45-DAY EXPRESS TERMS
FOR
PROPOSED BUILDING STANDARDS
OF THE
DIVISION OF THE STATE ARCHITECT (DSA-AC)

REGARDING THE CALIFORNIA BUILDING CODE
CALIFORNIA CODE OF REGULATIONS, TITLE 24, PART 2

2013 CALIFORNIA BUILDING CODE
INTERVENING CODE CYCLE

Figure 11B-411.2.1.2.3
Destination-Oriented Elevator Accessibility Function Button Indication

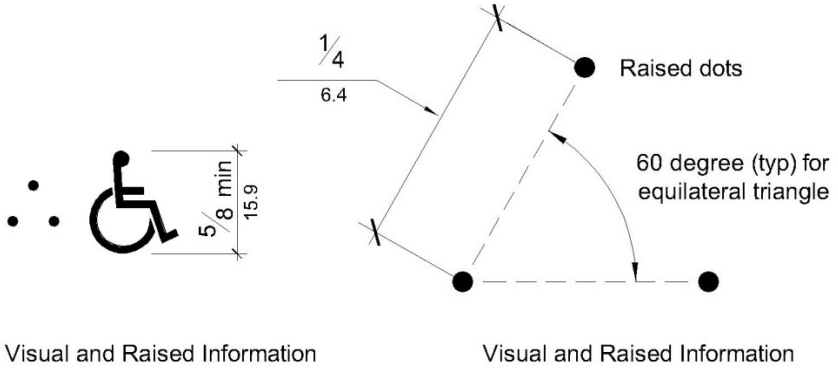
11B-411.2.1.2.3 Accessibility function button. *The accessibility function button shall be identified by the International Symbol of Accessibility and a raised indication. The International Symbol of Accessibility shall comply with Section 11B-703.7.2.1, and shall be 5/8 inch (15.9 mm) minimum in height. The indication shall be three raised dots. Each dot shall have a base diameter of 0.59 inch (1.5 mm) minimum and 0.063 inch (1.6 mm) maximum and a height of 0.025 inch (0.6 mm) minimum and 0.037 inch (0.9 mm) maximum. The dots shall be spaced ¼ inch (6.4 mm), measured center to center, in the form of an equilateral triangle with a vertex pointing up. The accessibility function button shall not be provided with a key repeat function.*

Figure 11B-411.2.3
Floor Designation and Car Designation Signs on Jambs
of Destination-Oriented Elevator Hoistway Signs

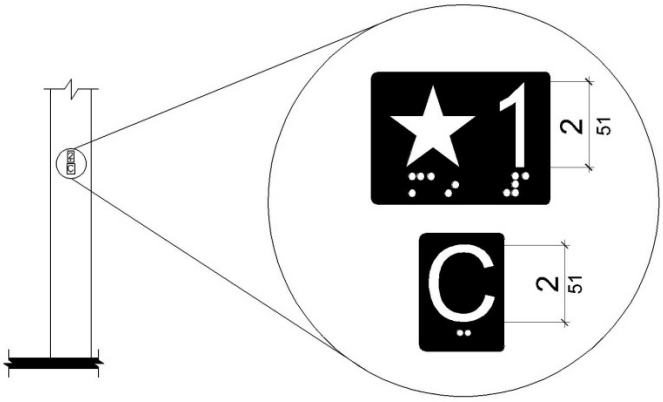
11B-411.2.3.1 Floor designation signs. *Floor designation signs complying with Sections 11B-703.2 and 11B-703.4.1 shall be provided on both jambs of elevator hoistway entrances. Signs shall be provided in both raised characters and Braille. Raised characters shall be 2 inches (51 mm) high. A raised star placed to the left of the floor designation, shall be provided on both jambs at the main entry level. The outside diameter of the star shall be 2 inches (51 mm) and all points shall be of equal length. Raised characters, including the star, shall be white on a black background. Braille complying with Section 11B-703.3 shall be placed below the corresponding raised characters and the star. The Braille translation for the star shall be "MAIN". Applied plates are acceptable if they are permanently fixed to the jamb.*

11B-411.2.3.2 Car designation signs. *Car designation signs complying with Sections 11B-703.2 and 11B-703.4.1 shall be provided on both jambs of the hoistway immediately below the floor designation. Signs shall be provided in both raised characters and Braille. Raised characters shall be 2 inches (51 mm) high. Raised characters shall be white on a black background. Braille complying with Section 11B-703.3 shall be placed below the corresponding raised characters. Applied plates are acceptable if they are permanently fixed to the jamb.*

Figure *11B*-407.2.3.1
Floor Designations on Jambs of Elevator Hoistway Entrances

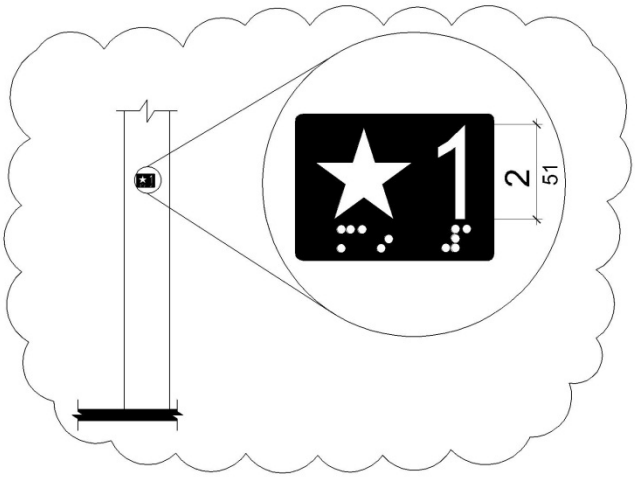
***11B*-407.2.3.1 Floor designation.** Floor designations complying with *Sections 11B*-703.2 and *11B*-703.4.1 shall be provided on both jambs of elevator hoistway entrances. Floor designations shall be provided in both *raised* characters and Braille. *Raised* characters shall be 2 inches (51 mm) high. A *raised* star*, placed to the left of the floor designation,* shall be provided on both jambs at the main entry level. *The outside diameter of the star shall be 2 inches (51 mm) and all points shall be of equal length. Raised characters, including the star, shall be white on a black background. Braille complying with Section 11B-703.3 shall be placed below the corresponding raised characters and the star. The Braille translation for the star shall be "MAIN". Applied plates are acceptable if they are permanently fixed to the jamb.*

~~Figure *11B*-407.2.3.2~~
~~Car Designations on Jambs of Destination-Oriented Elevator Hoistway Entrances~~ (end strikeout)

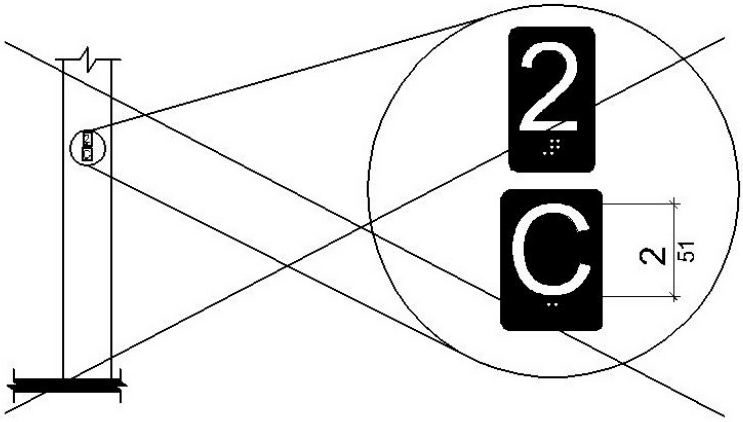
11B*-407.2.3.2** (begin underline) ***Reserved. (end underline) ~~**Car designations.** Destination-oriented elevators shall provide tactile car identification complying with *Sections 11B*-703.2 *and 11B-703.4.1* on both jambs of the hoistway immediately below the floor designation. Car designations shall be provided in both *raised* characters and Braille. *Raised* characters shall be 2 inches (51 mm) high. *Raised characters shall be white on a black background. Braille complying with Section 11B-703.3 shall be placed below the corresponding raised characters. Applied plates are acceptable if they are permanently fixed to the jamb.*~~ (end strikeout)

Figure 11B-703.8.5
Low Resolution VMS Signage Characters

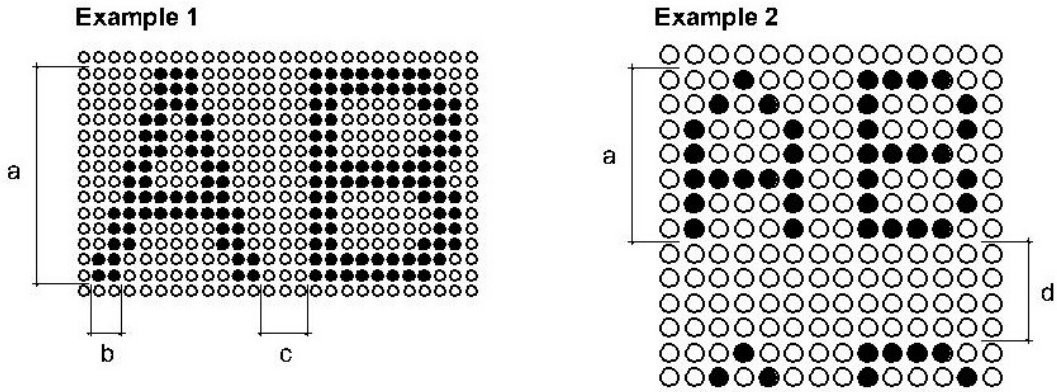
Table 11B-703.8.5 Pixel Count for Low Resolution VMS Signage

Character Height	***Character Width Range***	***Stroke Width Range***	***Character Spacing Range***
7	*5-6*	*1*	*2*
8	*6-7*	*1-2*	*2-3*
9	*6-8*	*1-2*	*2-3*
10	*7-9*	*2*	*2-4*
11	*8-10*	*2*	*2-4*
12	*8-11*	*2*	*3-4*
13	*9-12*	*2-3*	*3-5*
14	*10-13*	*2-3*	*3-5*
15	*11-14*	*2-3*	*3-5*
